NUMBER: SB 500-35-001, Rev B
MODEL: ECLIPSE EA500
SUBJECT: Crew Oxygen Mask Replacement

INJECTOR PLATE ASSEMBLY PN 270369 REPLACEMENT

Figure 1
Injector Plate Assembly PN 270369

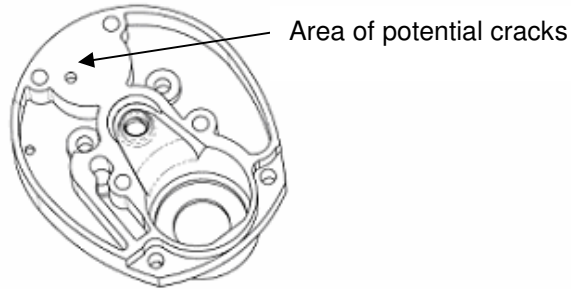
Leaks due to molding flaws can potentially cause a crack in the injector plate (refer to Figure 1). There is concern that if this condition is present, the regulator could leak and depressurize the oxygen supply. Based on the potential leakage of oxygen from the crew mask regulator injector plate assembly, the following actions are recommended as determined by individual aircraft crew system types:

1. For all operators of aircraft with masks of the effective part numbers listed that have a manufacturing date of Aug/2007 through Feb/2008 and oxygen capacities below 77 cu ft and masks stowed in a stowage box - return the mask for replacement of the injector plate.

2. For all operators of aircraft with masks of the effective part numbers listed that have a manufacturing date of Aug/2007 through Feb/2008 and oxygen capacities equal to or above 77 cu ft and masks stowed in a stowage box - return the mask for replacement of the injector plate at your next maintenance period or as available.

3. For all operators of aircraft with masks of the effective part numbers listed that have a manufacturing date of Aug/2007 through Feb/2008 and stowed in stowage cups or stowage pouches - perform audible preflight checks of the masks until they can be returned for replacement of the injector plate assembly.

Figure 3
Typical Label Marked with MOD Letter "V"

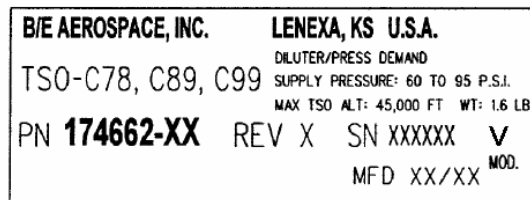
1. Mark the modified unit by turning the mask upside down to reveal the label. Mark the letter "V" above the word "MOD" on the label as shown in Figure 3 using "black" permanent ink, a decal, or replace the label as preferred.
